## PNCC RESOURCE CONSENT CONDITIONS

| LOCATION:        | 167-257 KENDALLS LINE, PALMERSTON NORTH       |
| PROPOSAL:        | EXPANSION AND OPERATION OF AN EXISTING QUARRY |
| APPLICATION:     | LU 6962                                       |

Figure F.1 Blasting Vibration Limits (Line 2)

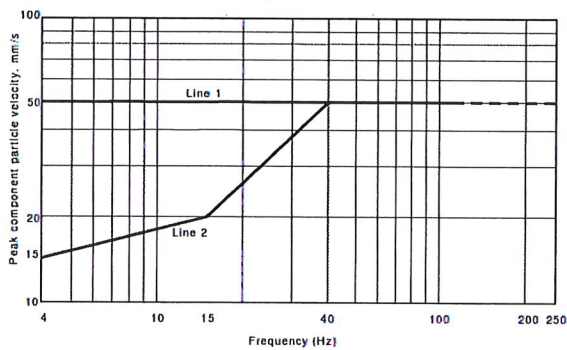
Blasting vibration must not exceed the peak component particle velocity shown as Line 2 in Fig F.1 when measured at the base of any dwelling. Blasting must be managed to ensure that in any calendar year, 95% of airblast levels do not exceed 115 dBL, with a maximum of 120 dBL, when applied at or within any residentially zoned site or at or within the notional boundary of any rural dwelling.
